ADDENDUM NO. 3

DATED: November 14, 2024

PROJECT:	WSD New Sr. High School	**DATE:**	11/14/2024
OWNER:	Wynne School District	**PROJECT NO:**	A-23010
TO:	Gary Hoyt Nabholz Construction	**CONTRACT FOR**:	General Construction

1 OVERALL SITE PLAN

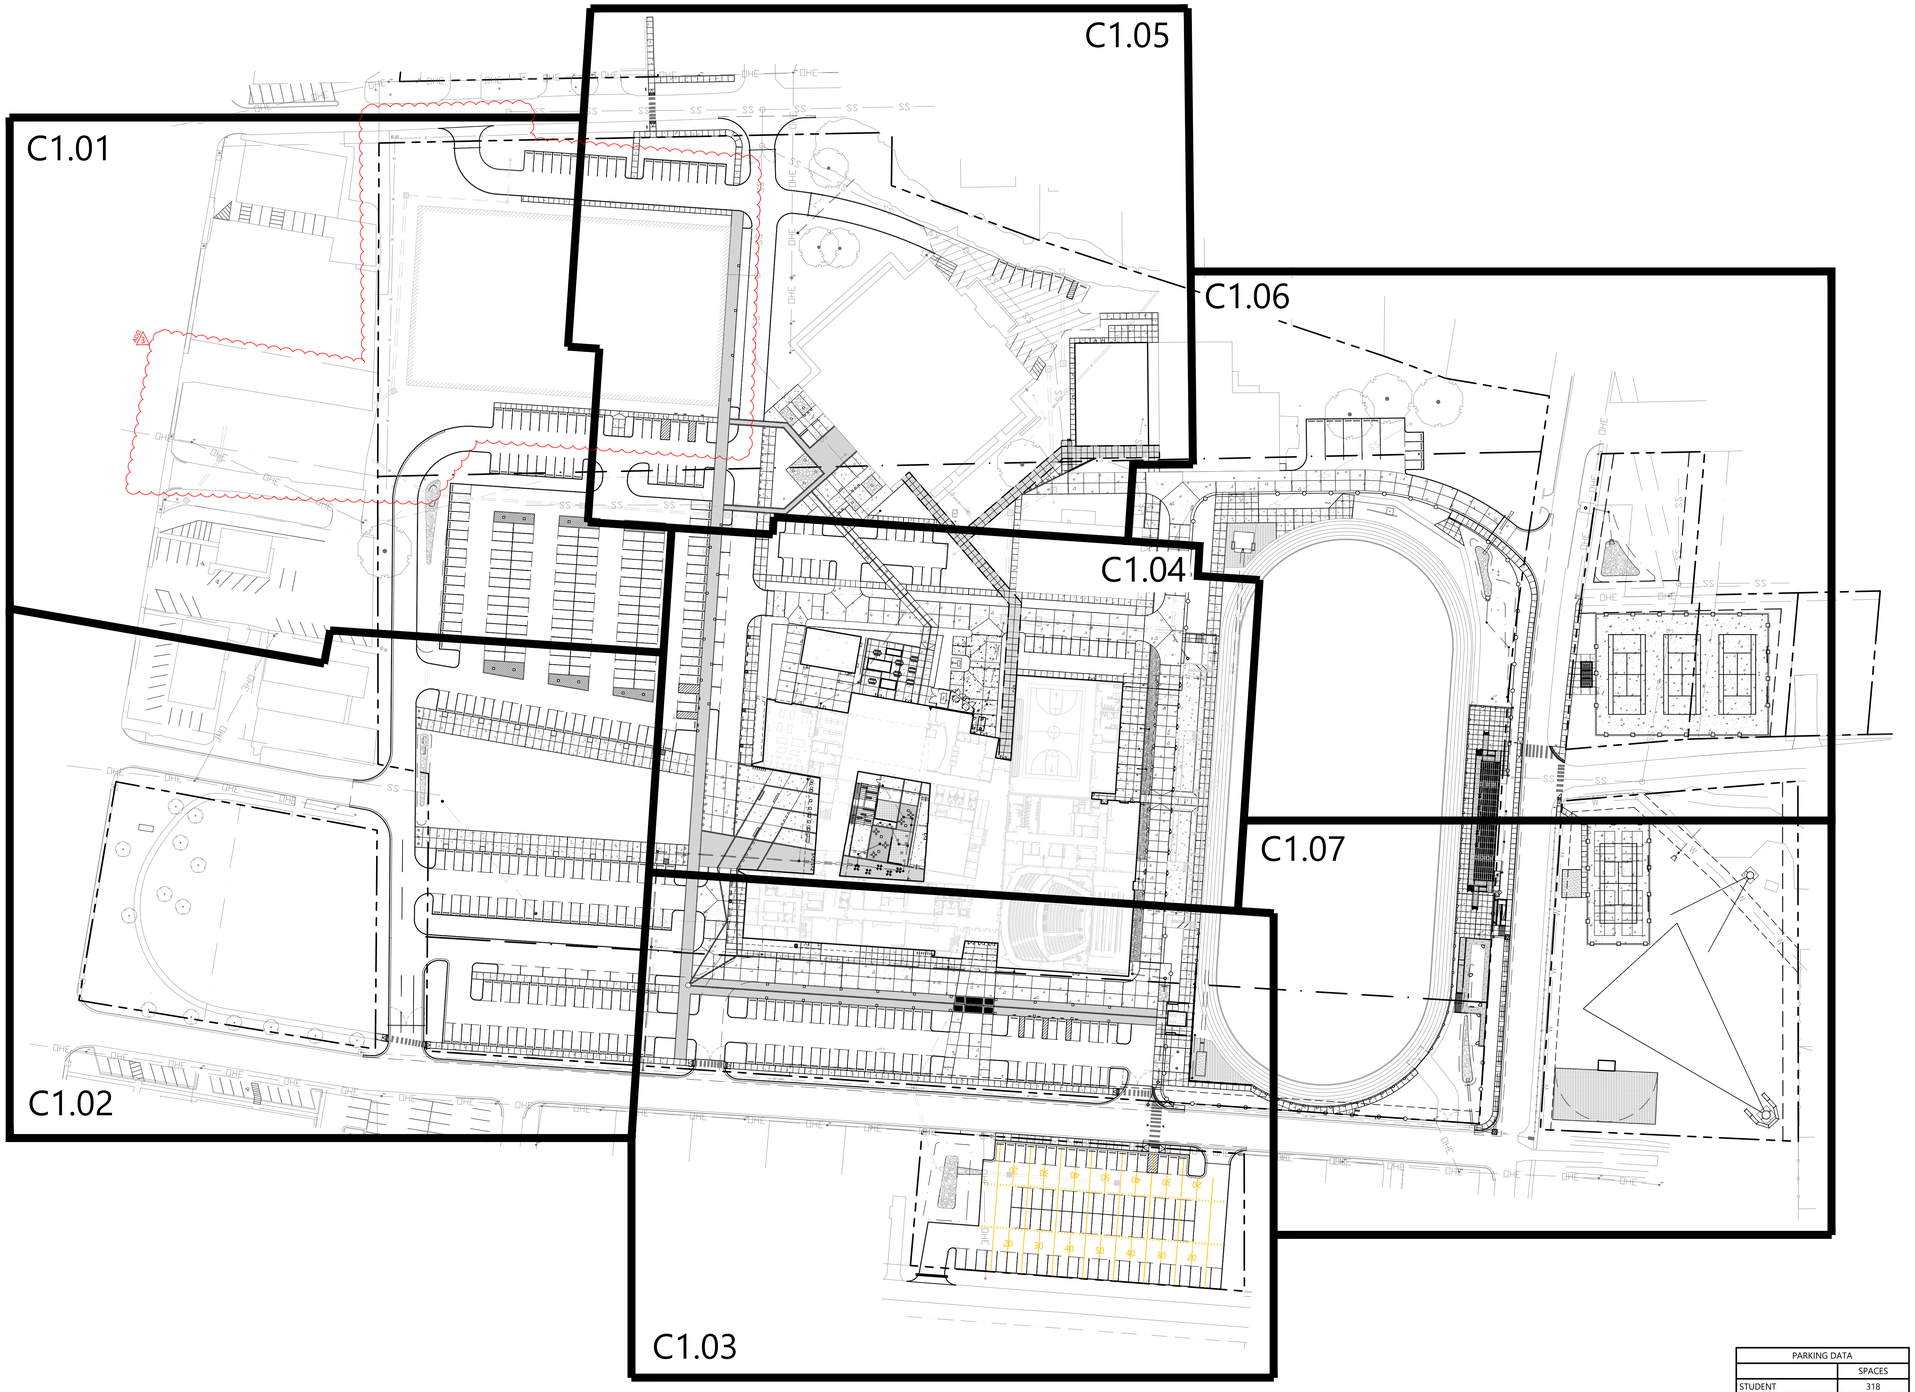
1. Deductive alternate for courtyard stairs.
2. Sheet C1.00 OVERALL SITE PLAN: Drawing has been updated and revised as indicated on drawing sheet.
3. Sheet C1.01 SITE PLAN: Drawing has been updated and revised as indicated on drawing sheet.

SHEET NUMBER
C1.03

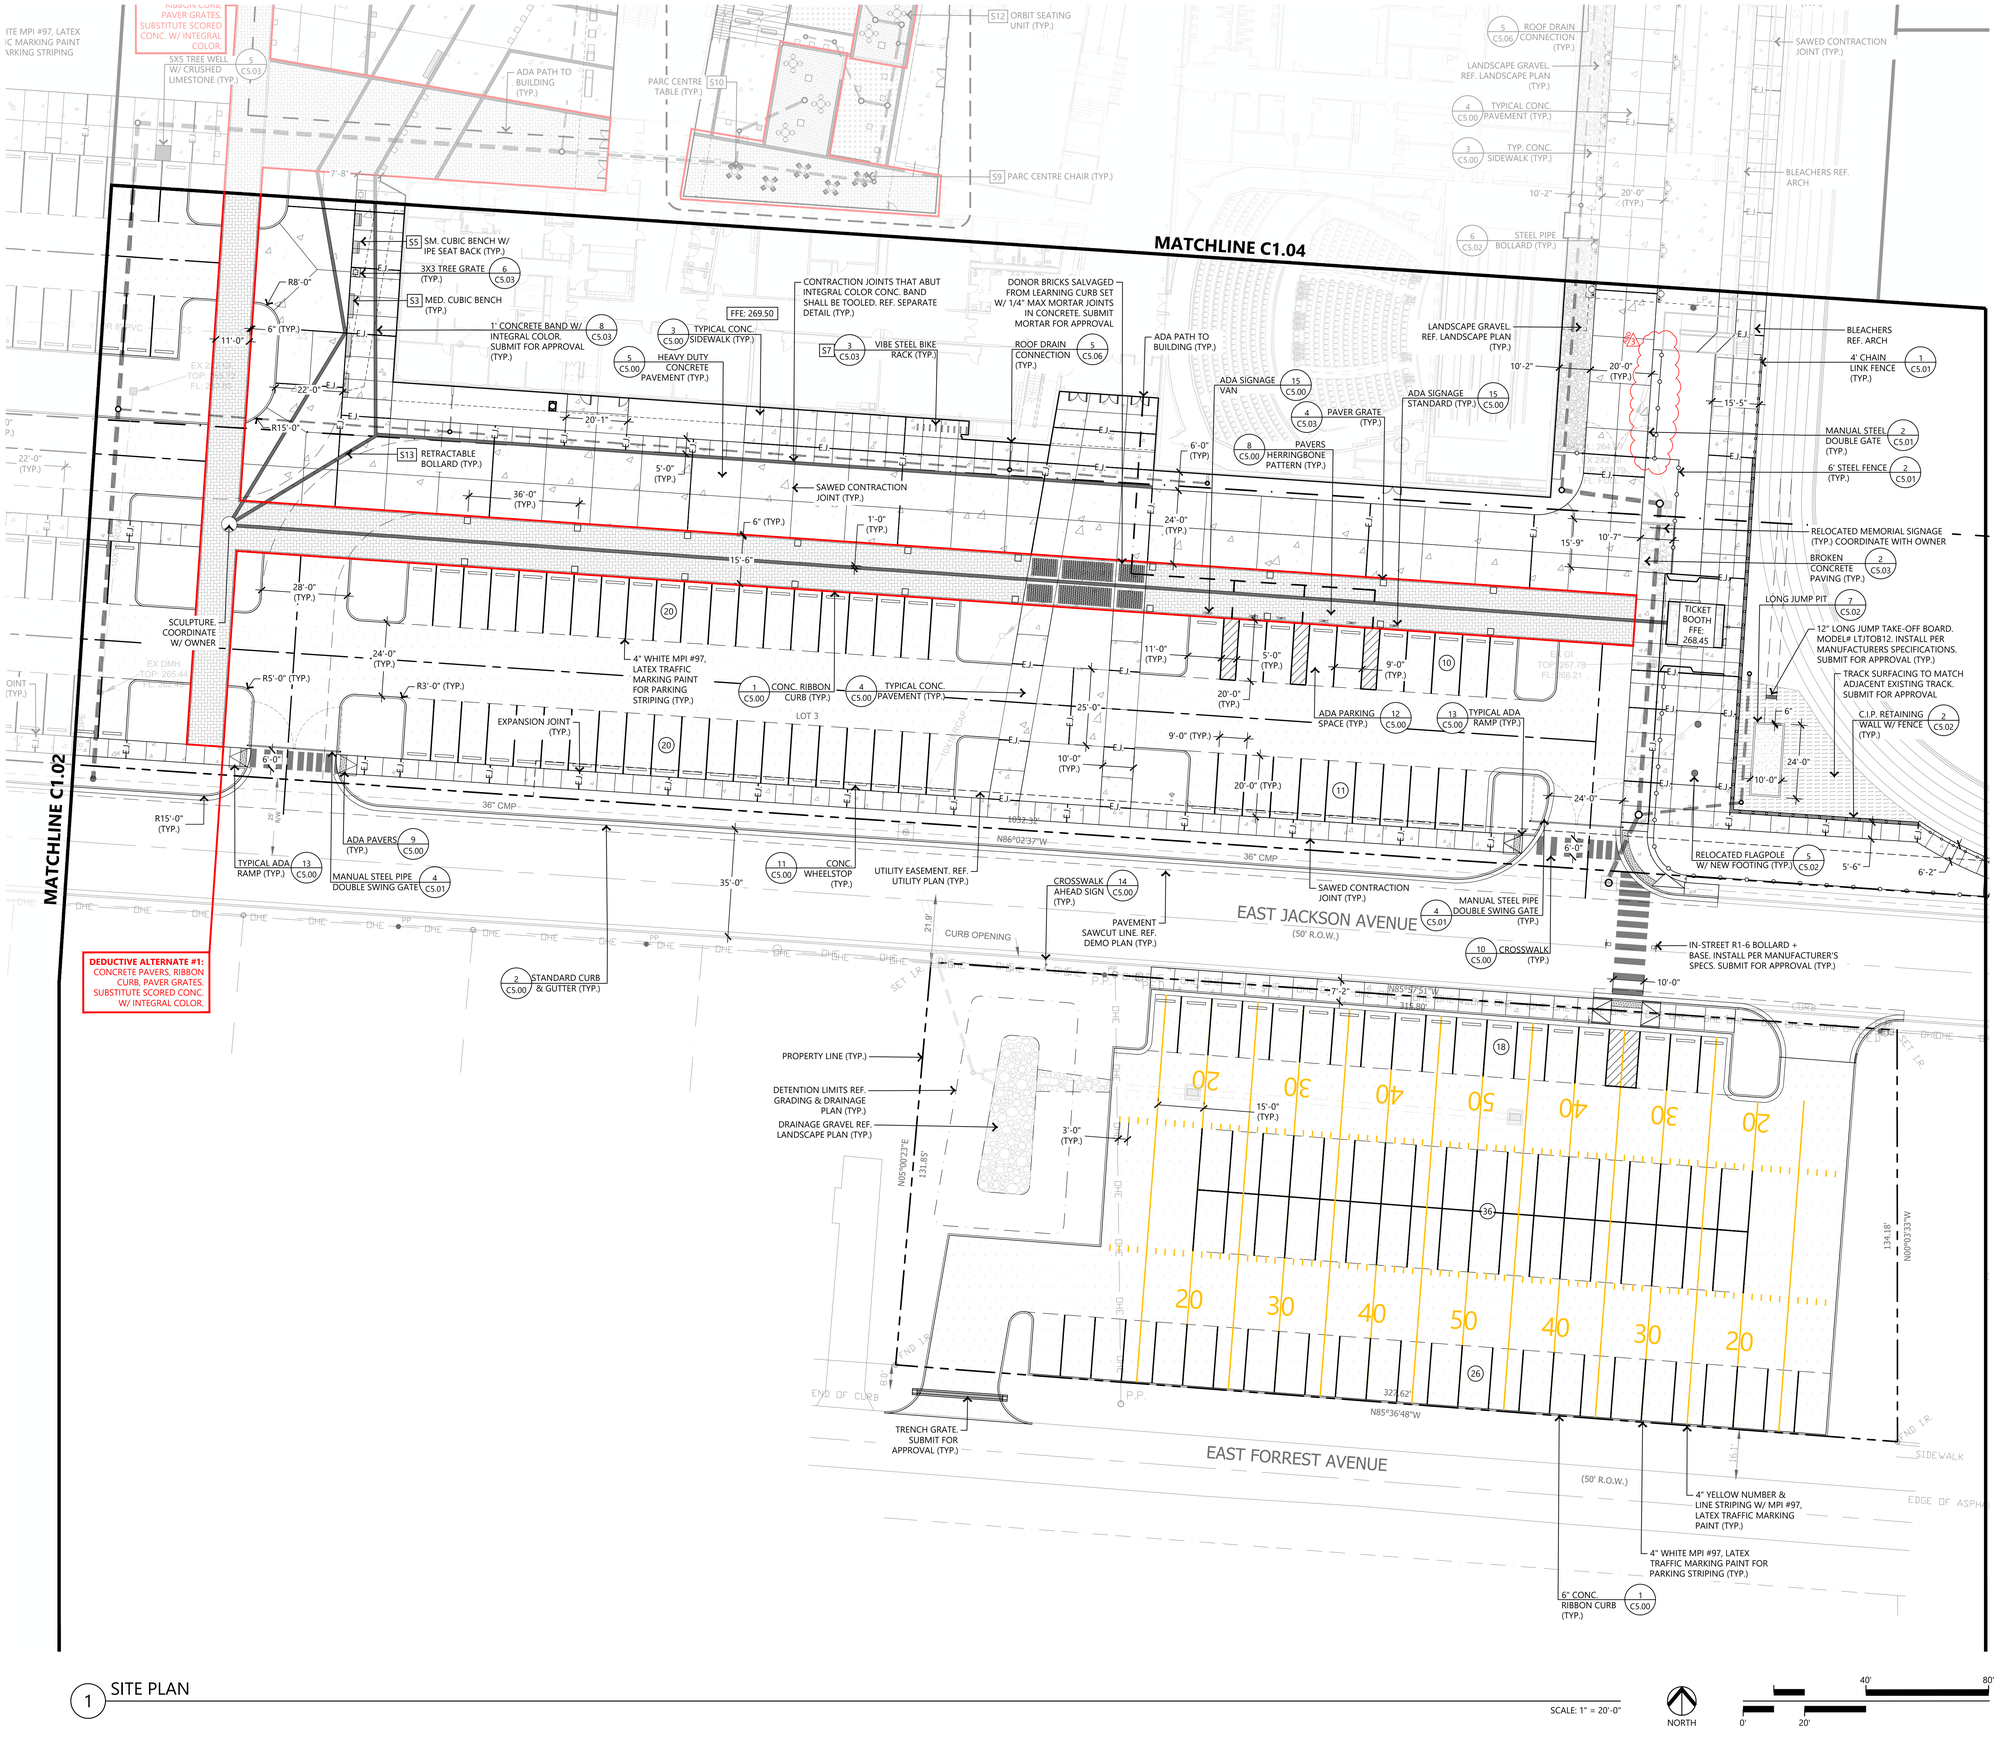
4. Sheet C1.03 SITE PLAN: Drawing has been updated and revised as indicated on drawing sheet.
5. Sheet C1.04 SITE PLAN: Drawing has been updated and revised as indicated on drawing sheet.

SHEET NUMBER
C1.05

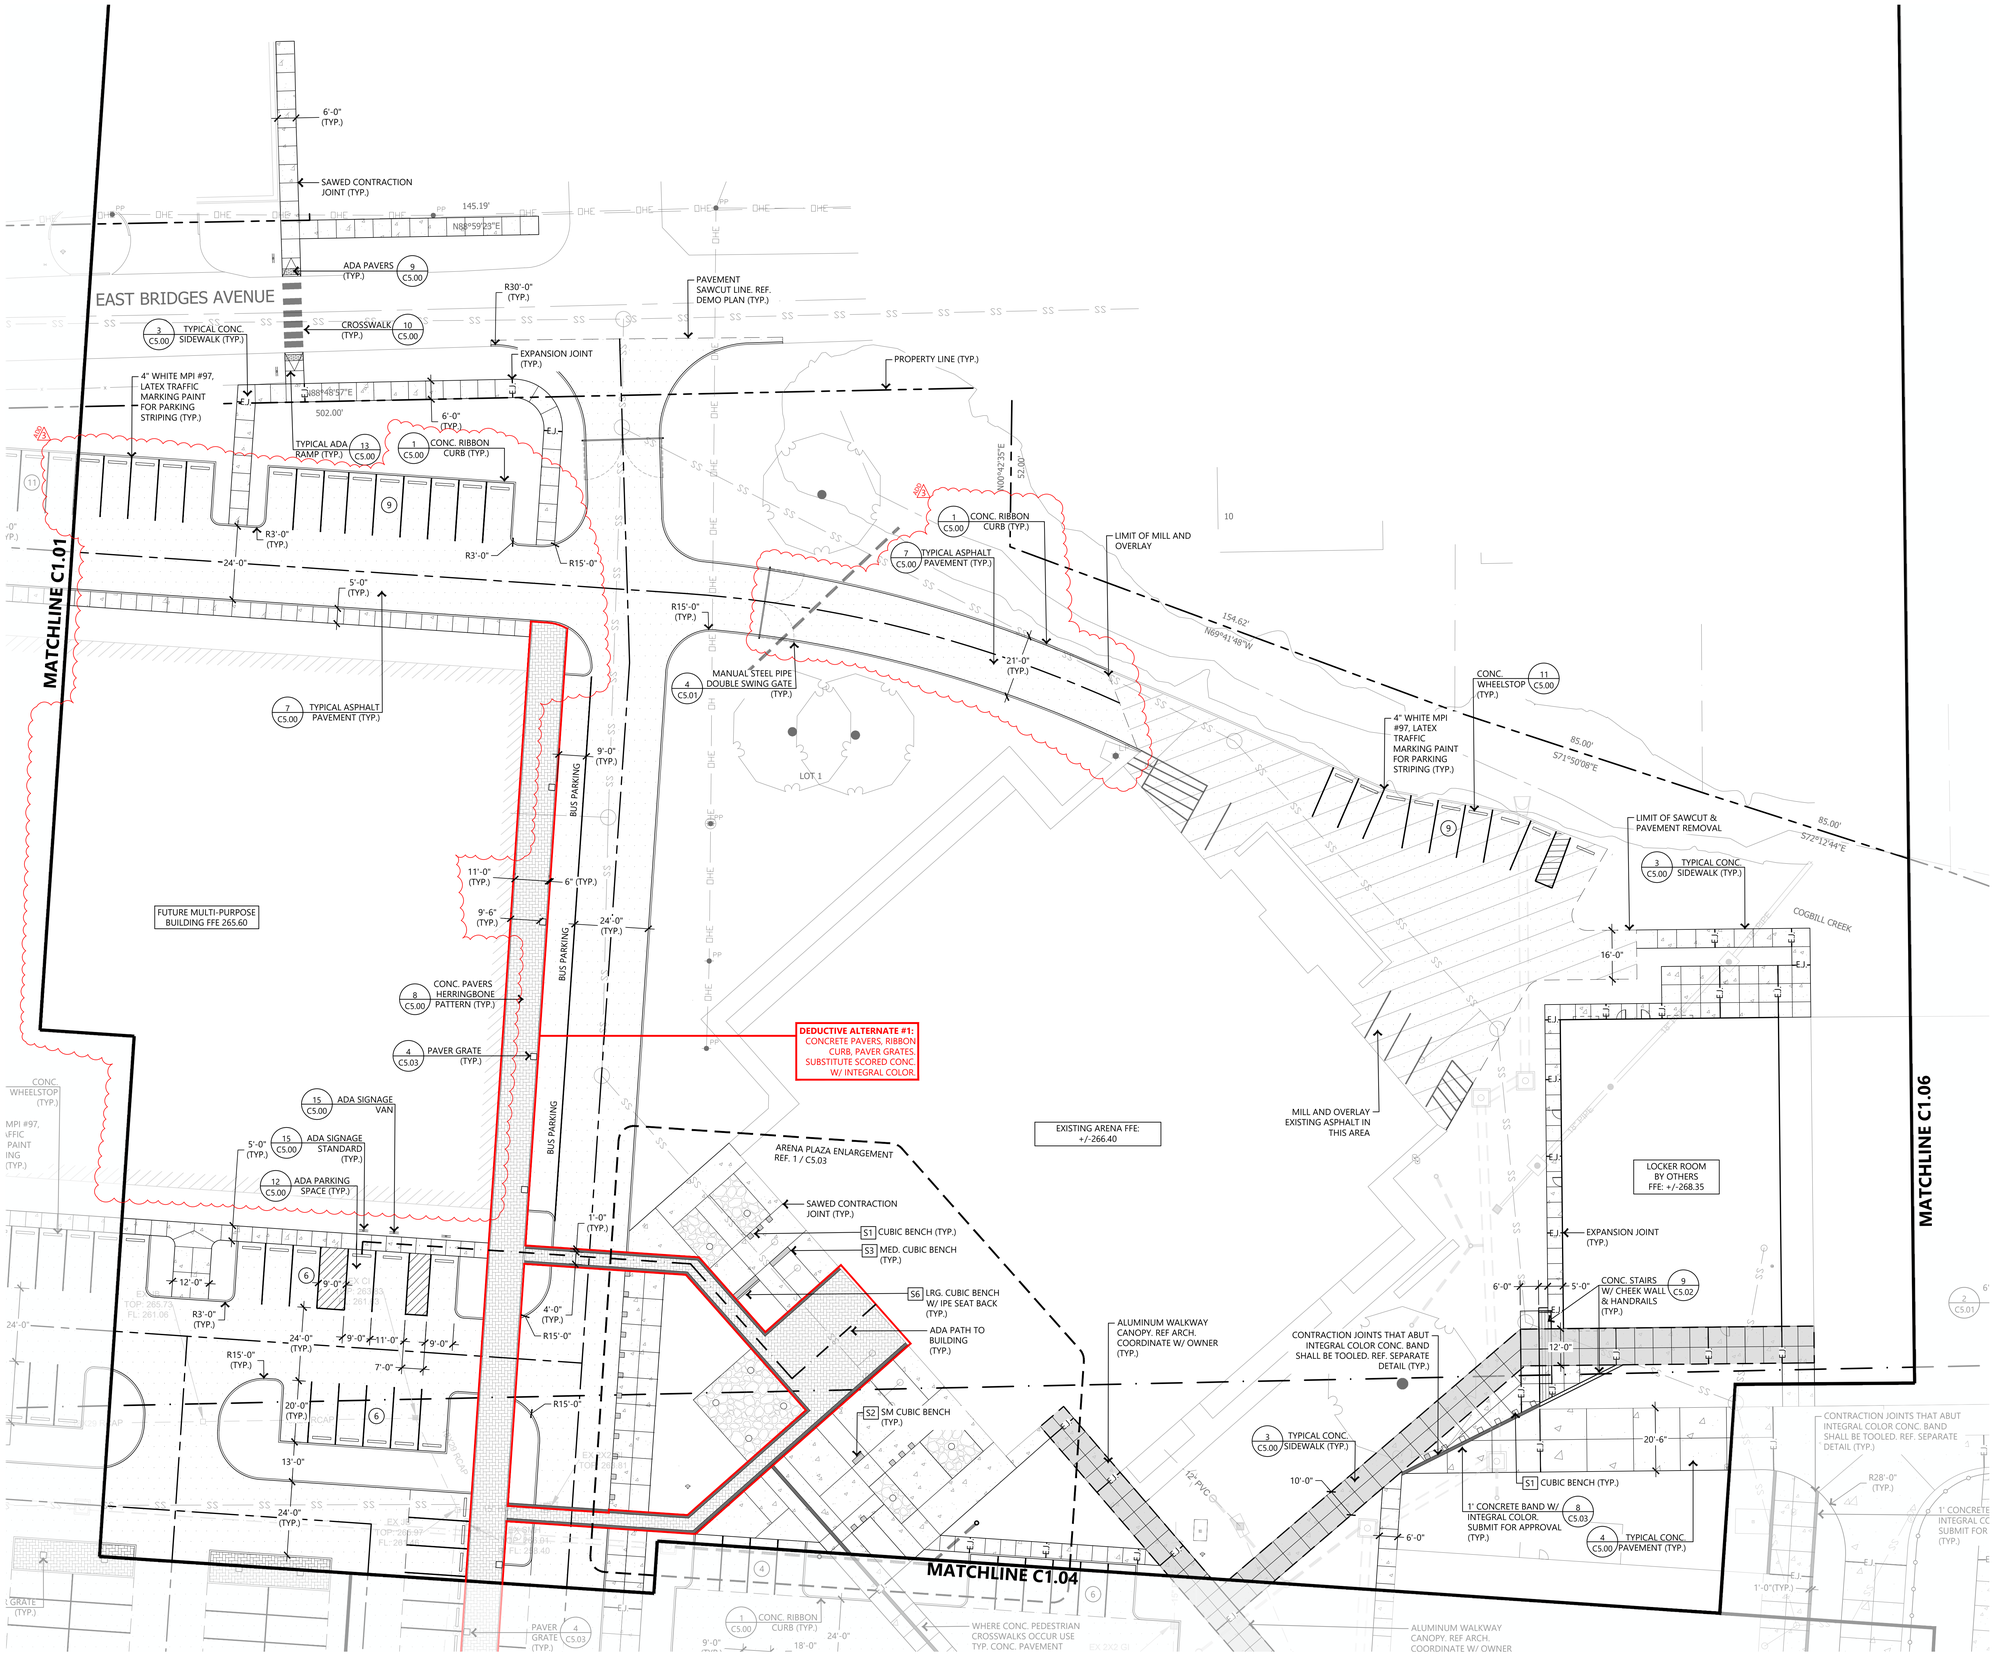
6. Sheet C1.05 SITE PLAN: Drawing has been updated and revised as indicated on drawing sheet.
7. Sheet C1.06 SITE PLAN: Drawing has been updated and revised as indicated on drawing sheet.
